Appendix E

**July 27, 2010, Engineer's Review and Analysis Report,
Balzer and Associates**

**Re: Environmental Impact Review for the Proposed Virginia State Law Enforcement
Training Facility (VSLETF) – Old River Trail, Powhatan County, Virginia**

TRAJECTORY ANGLE CALCULATION
BY METHOD OF COMPUTER AIDED DESIGN

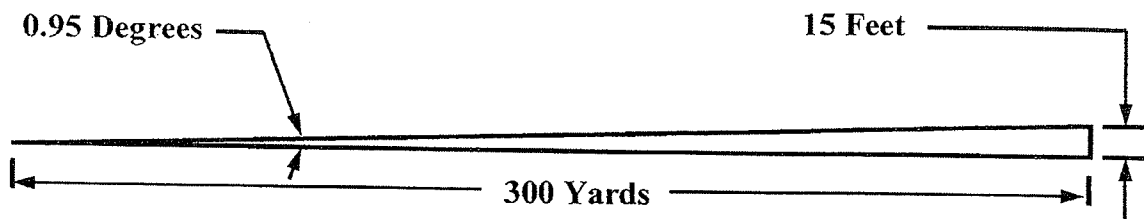
According to calculations performed by Mr. Stokes a retired army officer who served at as a range officer during his career, if a shooter misjudged the target by an increase of approximately 1° of elevation from the firing line the bullet would clear the berm behind the target 300 yards downrange, and hurtle toward a car on Route 6 or one of the residences in the line of fire situated in the SDZ. See Exhibit # 7 attached hereto. We must remember that this is a practice range and that errant rounds are a reality on firing ranges. Accordingly no comfort can be taken in the VSP's cavalier comments that they do not anticipate their shooters will exceed the berm. Indeed, the Balzer Report demonstrates that a mere 0.3° error in elevation will cause a rifle projectile to pass over the berm and into Goochland County. The bottom line is that the range is ill conceived, ill designed, and will put citizens of this Commonwealth at risk by its utilization at this location.

Berm Height (ft)	Range Length (ft)	Angle of Escape Trajectory (Degrees)
15	900	0.95
20	900	1.27
25	900	1.59
30	900	1.91
35	900	2.23
40	900	2.54

Note: Angles in table derived by trigonometry: Angle = Inverse Tangent of (Berm Height / Range Length).

Figure 4-1 Sheet C-1 Surface Danger Zone (SDZ) Plan

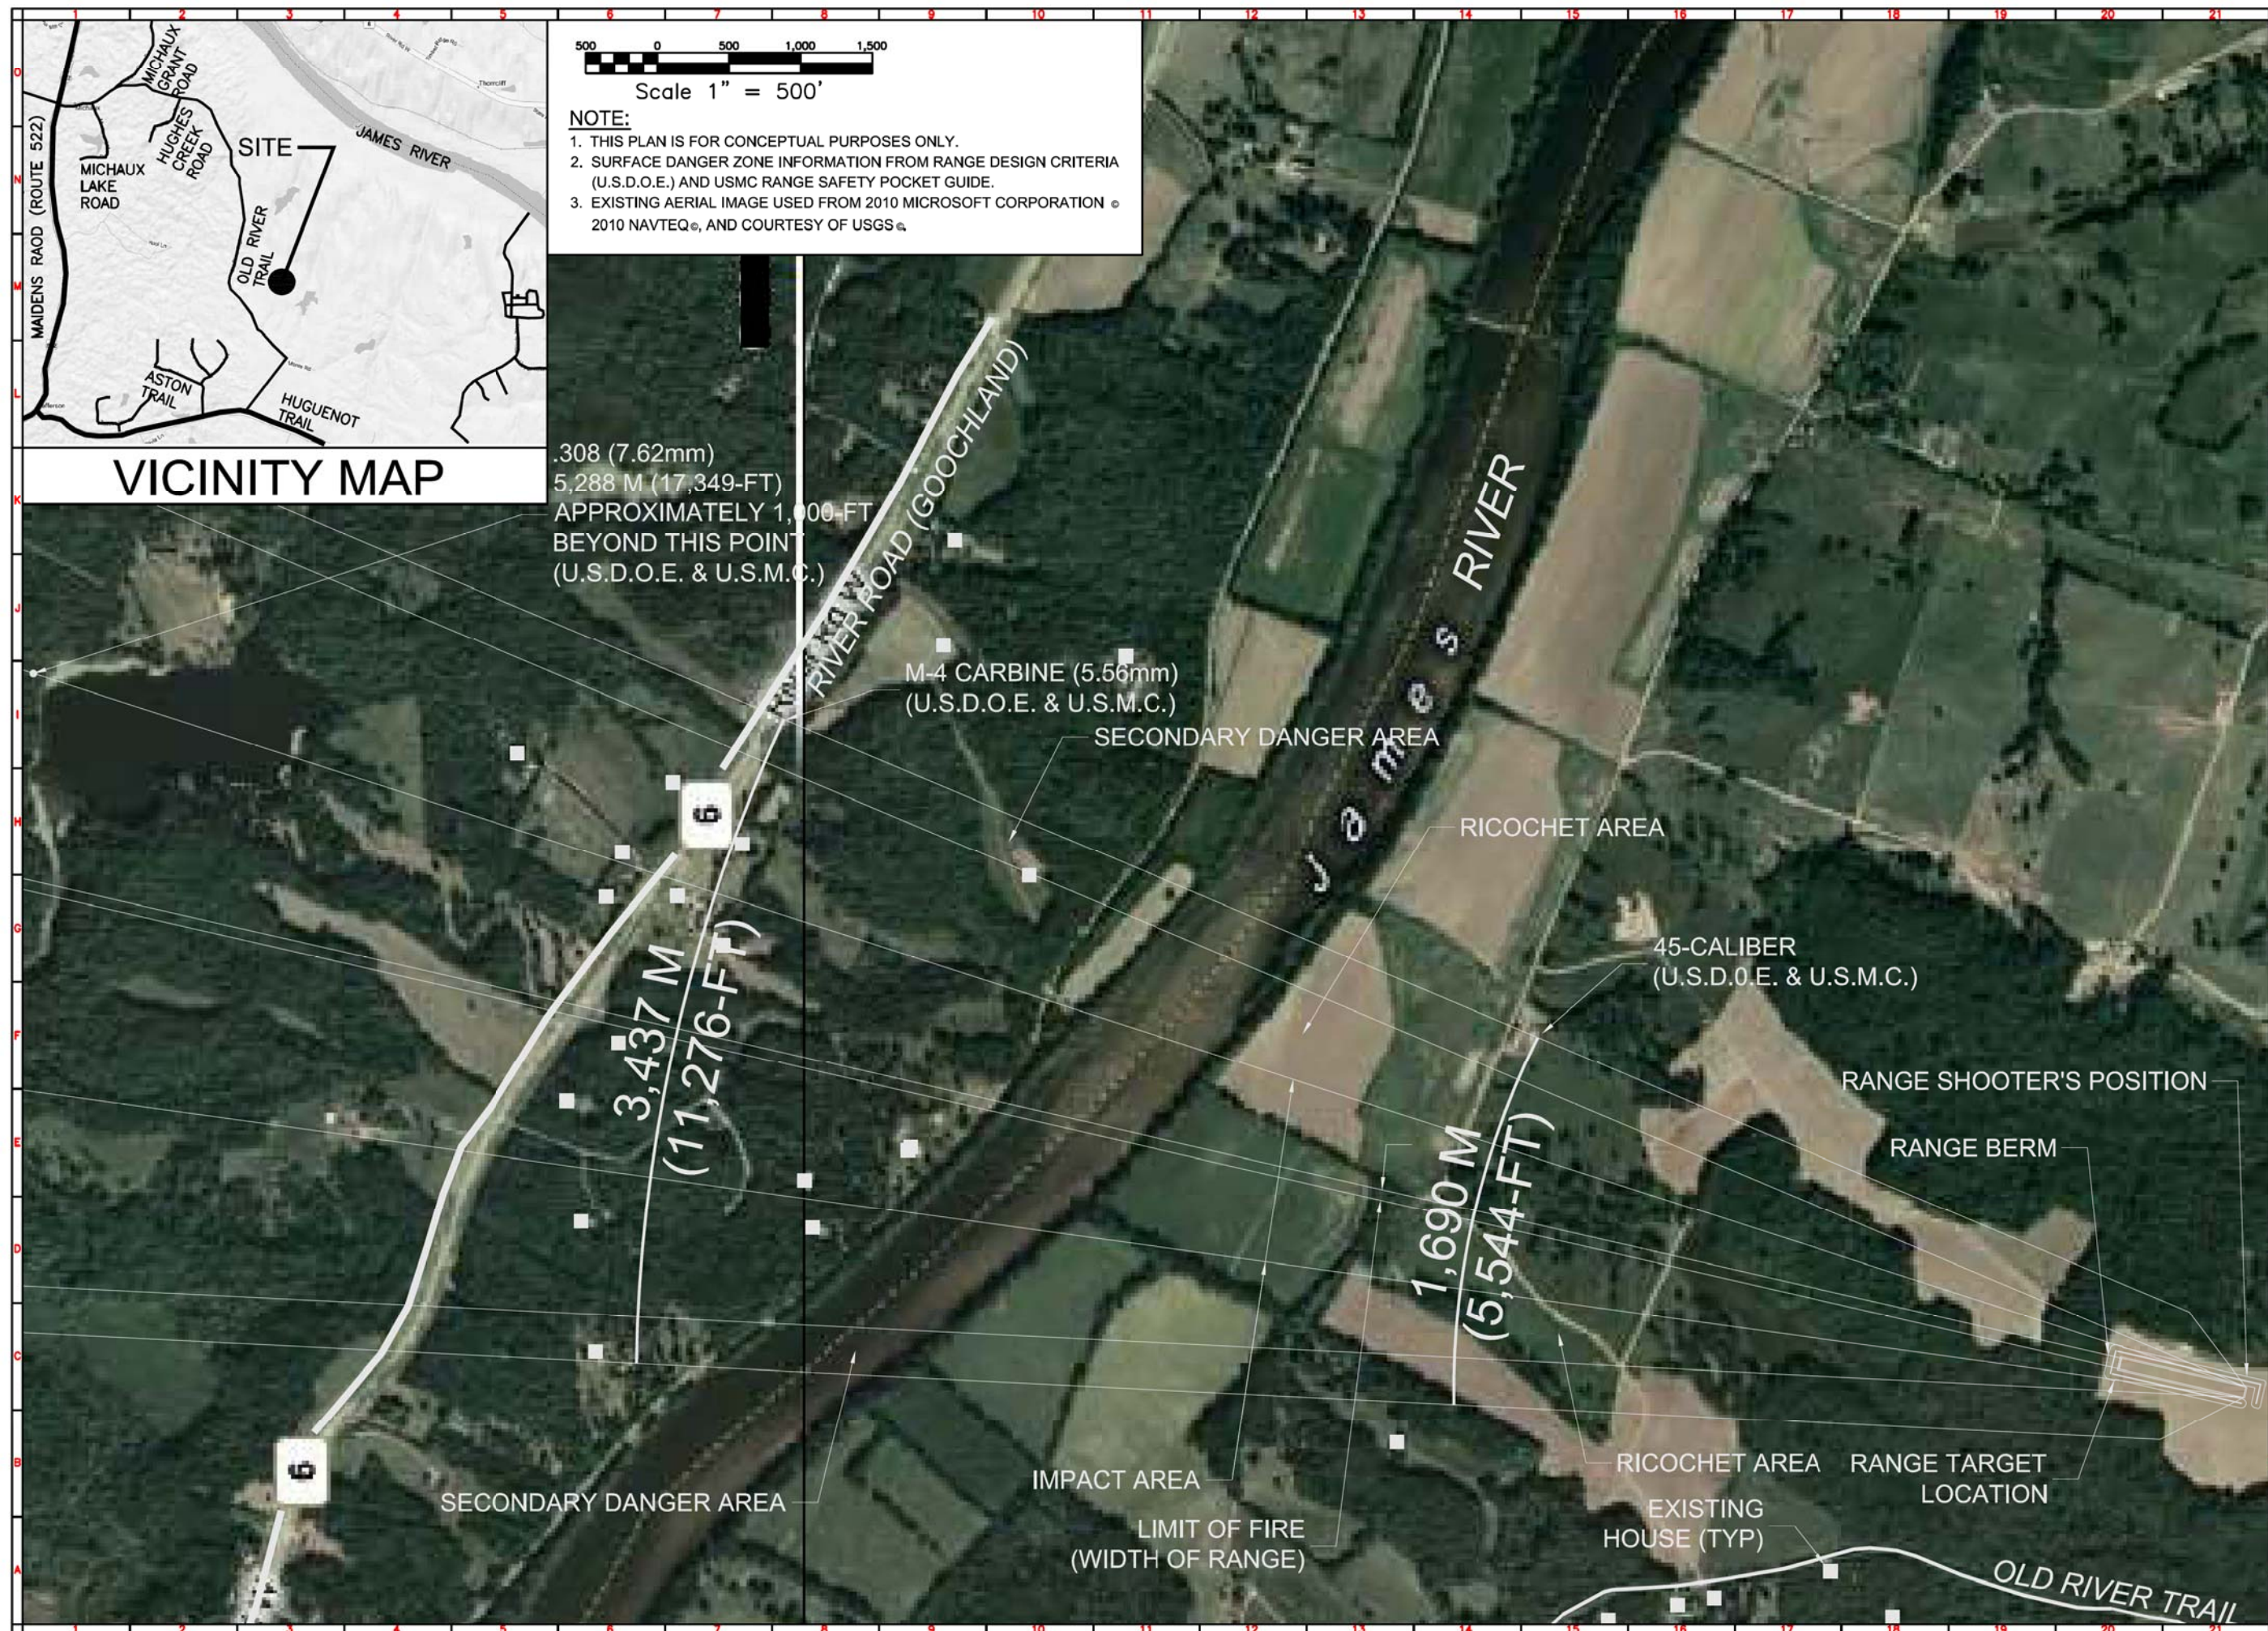
When considering a location for construction of a firing range, the surface danger zone (SDZ) should be evaluated based on the types of firearms that are going to be permitted at the range. In the case of the Powhatan site, the FBI has indicated that they will be firing numerous types of weapons including .45-caliber pistols, M-4 (.223-caliber) rifles, and .308-long range rifles. The Department of Energy Office of Health, Safety, and Security regulate SDZ requirements (refer to Appendix A for Range Design Criteria). A copy of the United States Marine Corps Range Safety Pocket Guide (Appendix B) has also been included to demonstrate the consistency of governmental standards used for SDZ evaluation. When the SDZ criteria for the three weapons above are superimposed over an aerial image of the area surrounding the proposed firing range, it becomes immediately apparent that the SDZ encroaches on residential properties located across the James River, in Goochland County. The SDZ for the .308-long range rifle is over 3-miles long. Figure 4-1 and 4-2 show the limits of the surface danger zones for the weapons listed above.

While the firing range has been designed with perimeter berms to deter bullets from travelling the maximum trajectories in the SDZ, there is a potential flaw in the firing range/berm design. The range has been designed with the target area located lower than the shooter's pad. For the 300-yard range, the top of berm behind the target is located 950-ft from the shooter with a 1.7% down-grade slope. In this scenario, a level shot from the shooter would intercept the berm only 4-ft from the top of the berm, if the shooter is in the prone position and would clear the berm if the shooter were in a position with the rifle located 4-ft above the shooting pad. Additionally, it would only take a 0.3-degree margin of error in the scope calibration of the shooter's accuracy for a bullet to potentially clear the berm behind the target area.

Figure 5-2 Sheet C-3 Sound Plan

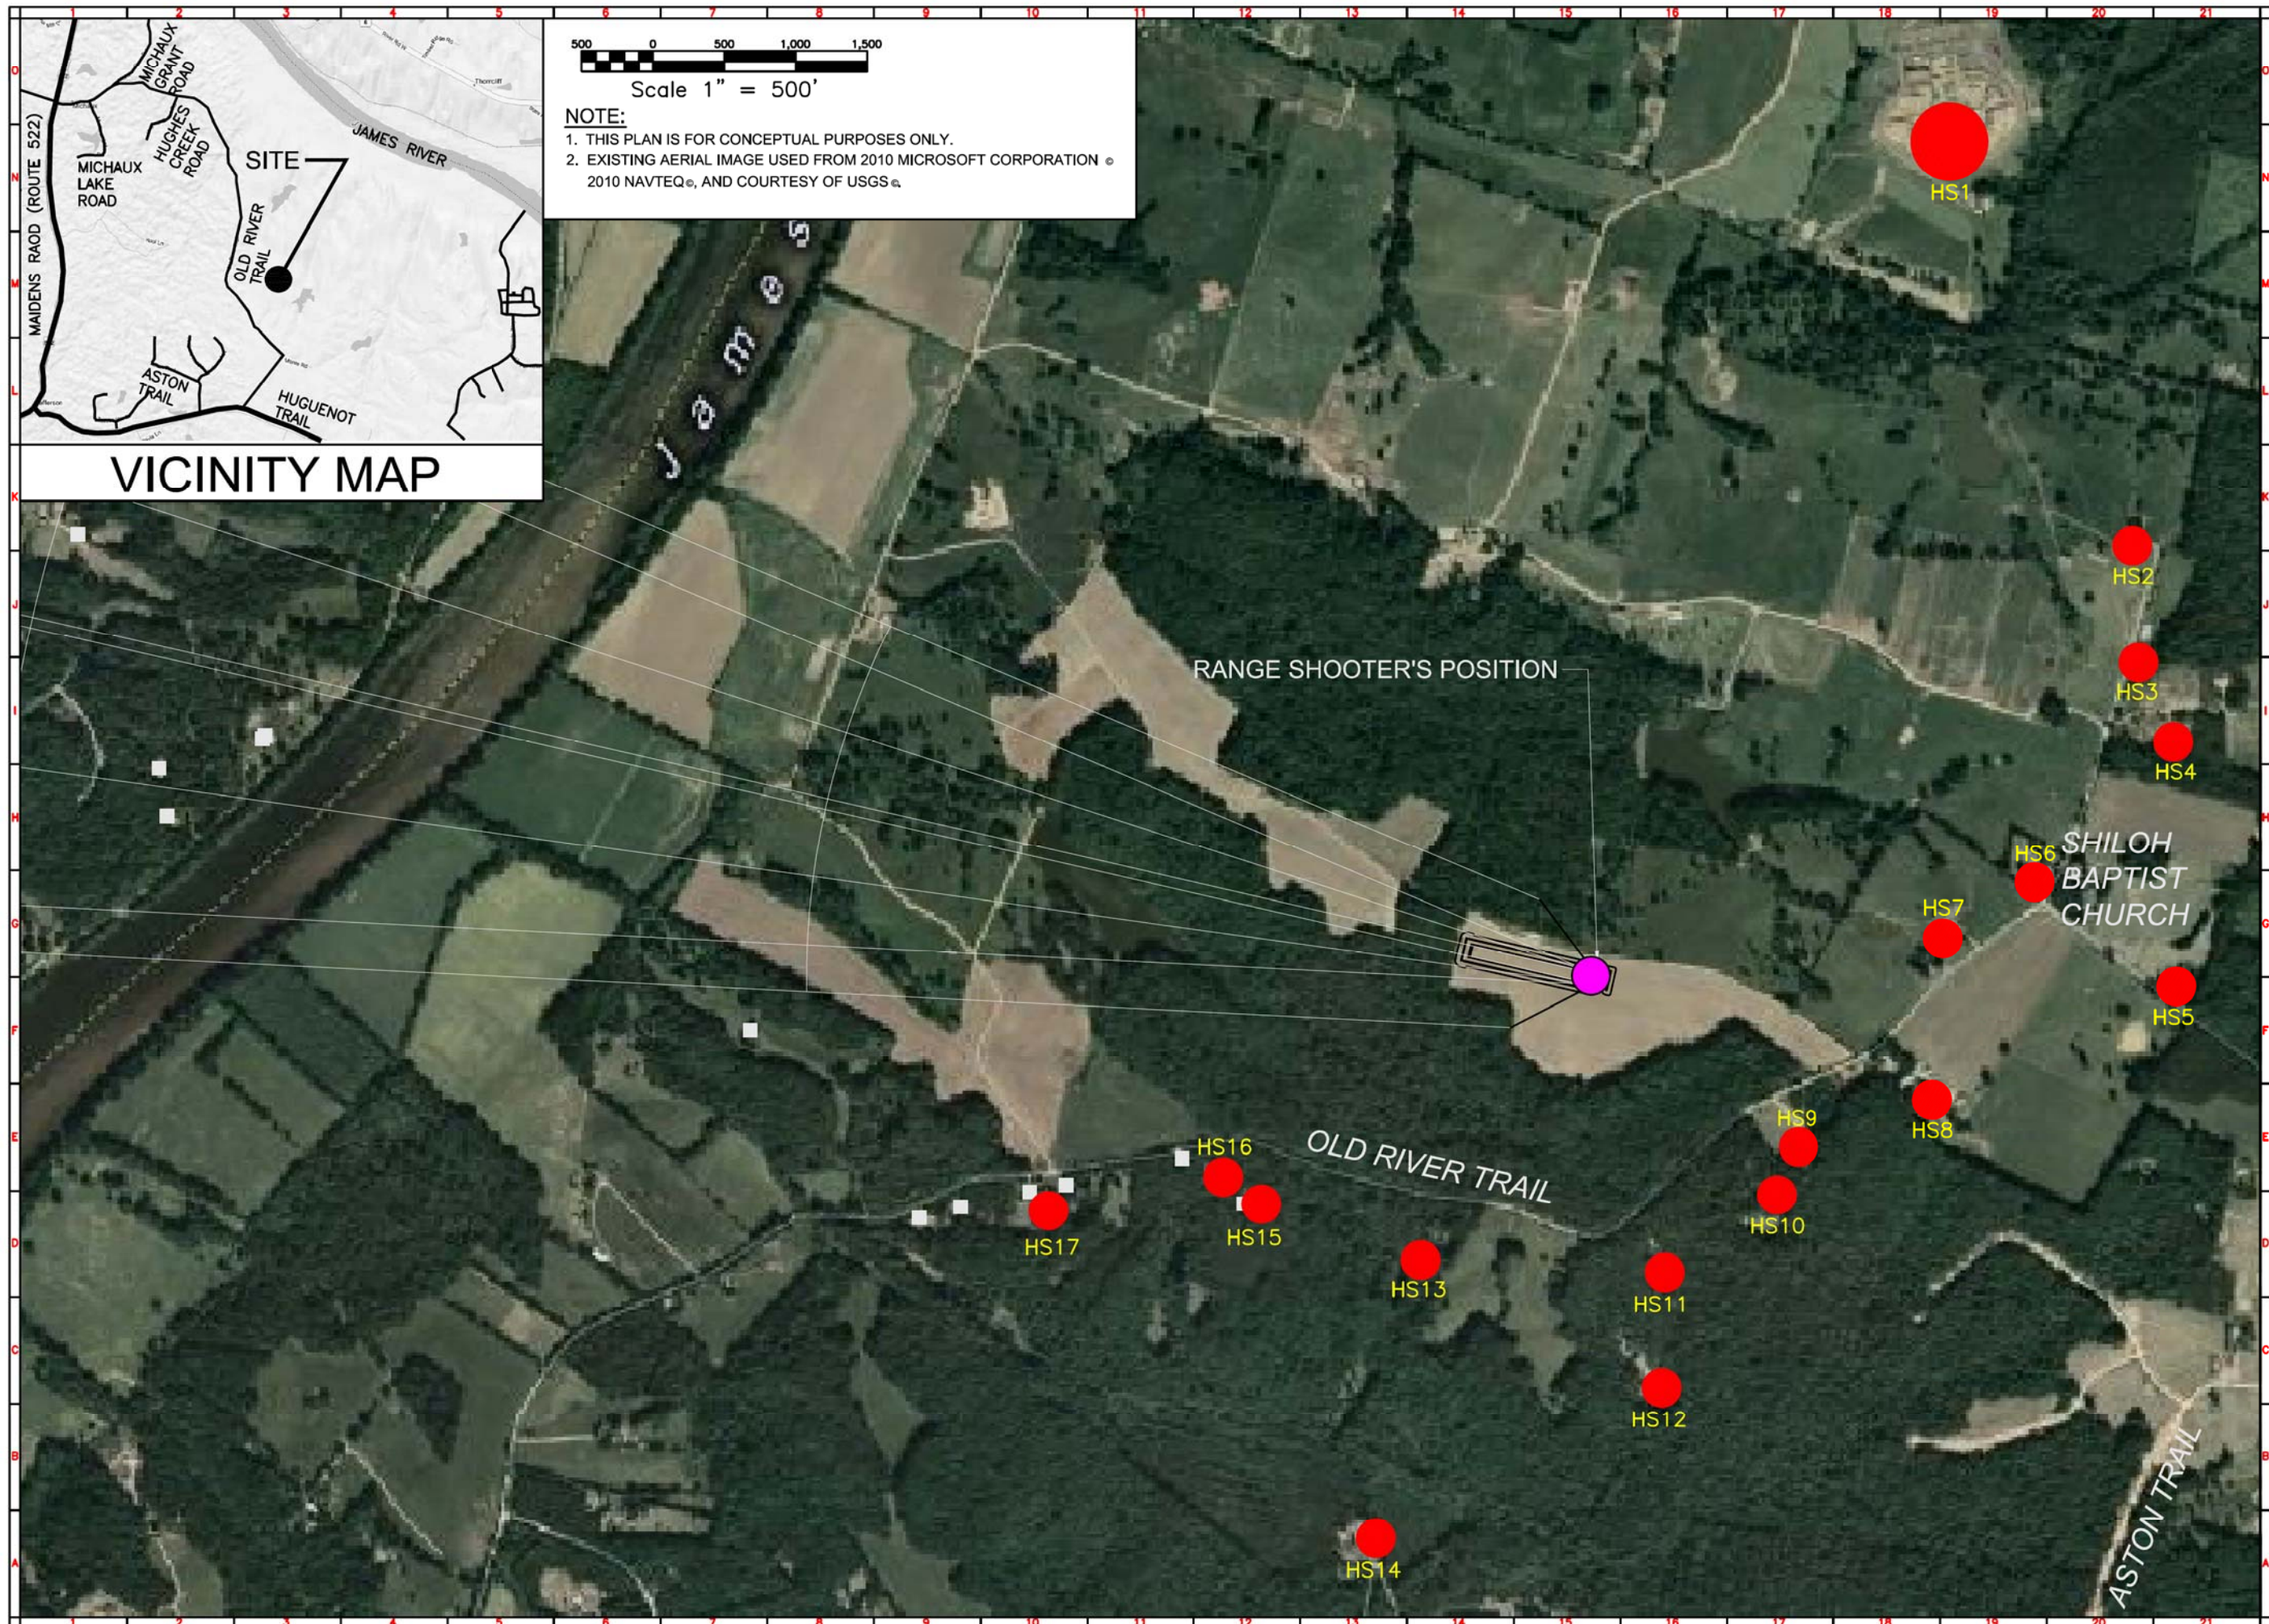
In terms of the noise that the surrounding residential and agricultural areas will be exposed to, the impact would be considered significant. Based on the sound study performed for the firing range, the existing homes located in the vicinity (Figure C3) of the proposed range would experience noise levels comparable to an airplane taxiing on a runway or a locomotive horn being sounding at a crossing. The summary of HS-NL Data Table (Home Site Noise Level) shows the expected noise levels with the current design. For all 17 home sites considered (including Shiloh Baptist Church and the inmate housing area), the noise levels exceed 74 dB and are as high as 90.6 dB. Again, levels that are consistent with airplane and locomotive noise.
